# STATE OF OHIO DEPARTMENT OF TRANSPORTATION

## GRE-68-12.65

### BUILDABLE UNIT #3 AND #4

**INTERIM SUBMITTAL  
DATE: 02/17/2025**

TRAFFIC CONTROL PLANS - U.S. 68  
 STA. 95+75.00 TO STA. 105+75.00

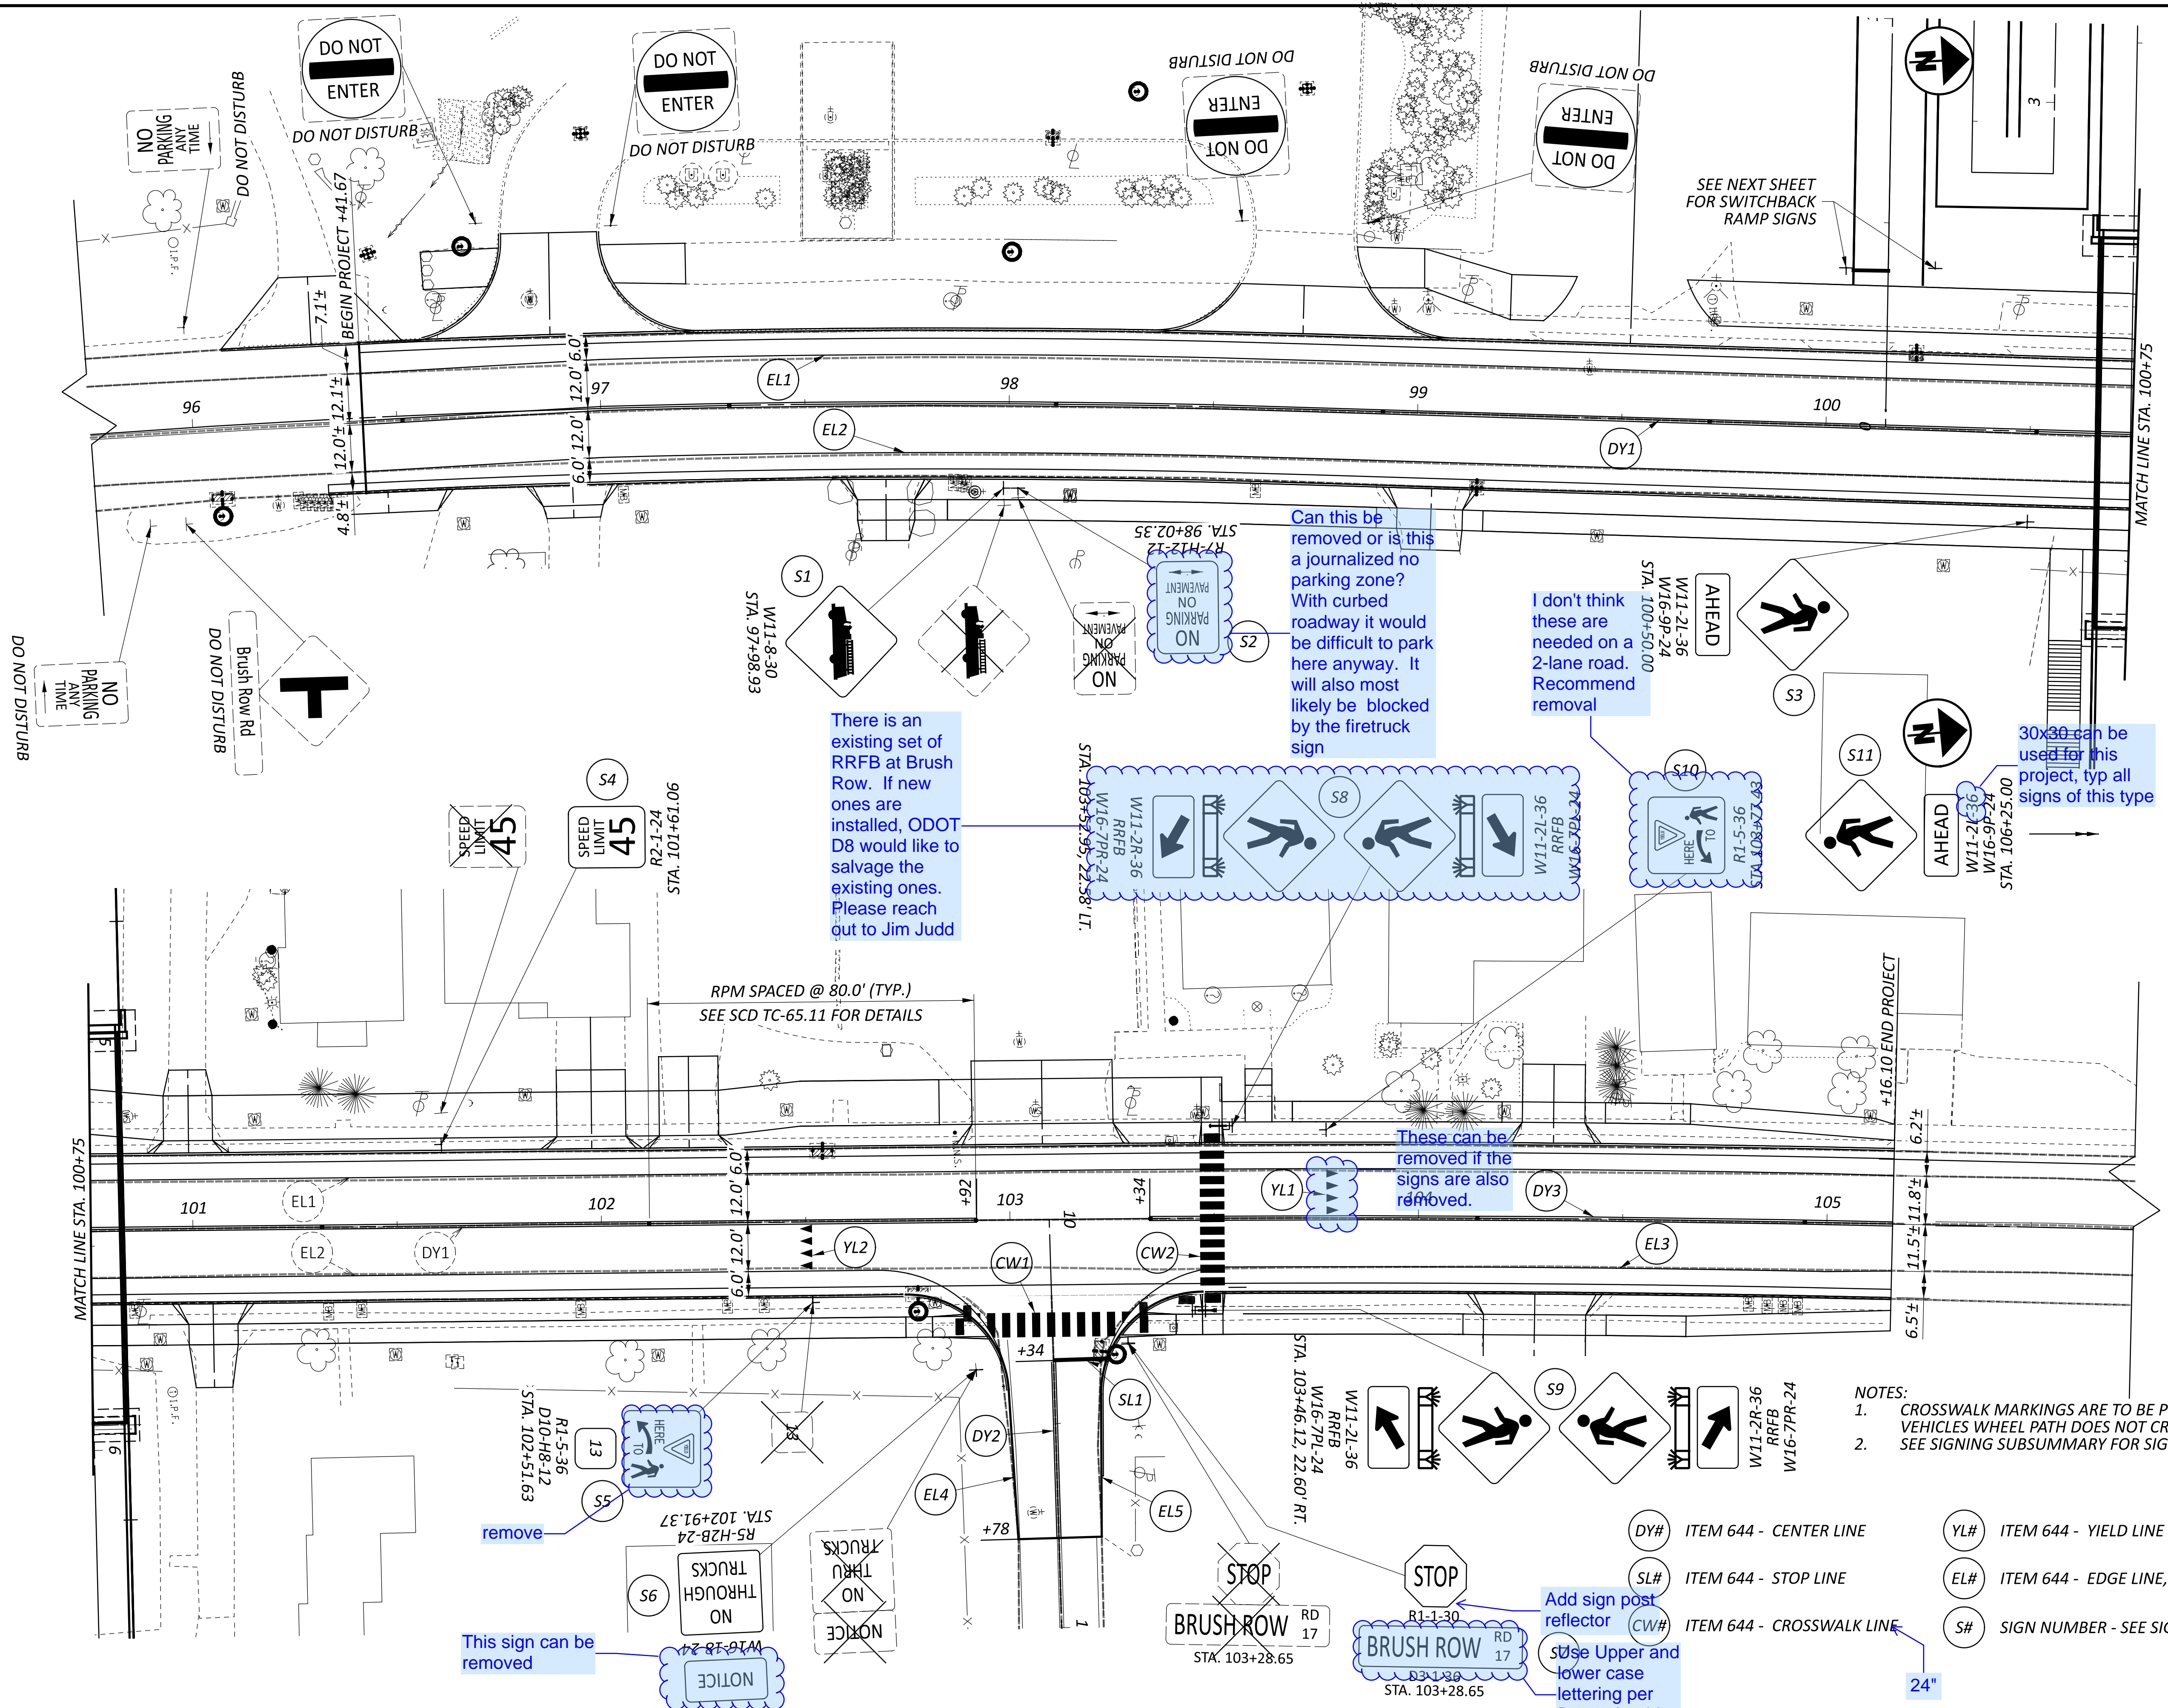
There is an existing set of RRFB at Brush Row. If new ones are installed, ODOT D8 would like to salvage the existing ones. Please reach out to Jim Judd

Can this be removed or is this a journalized no parking zone? With curbed roadway it would be difficult to park here anyway. It will also most likely be blocked by the firetruck sign

Add sign post reflector  
 Stage upper and lower case lettering per D3-1. should be dual sided
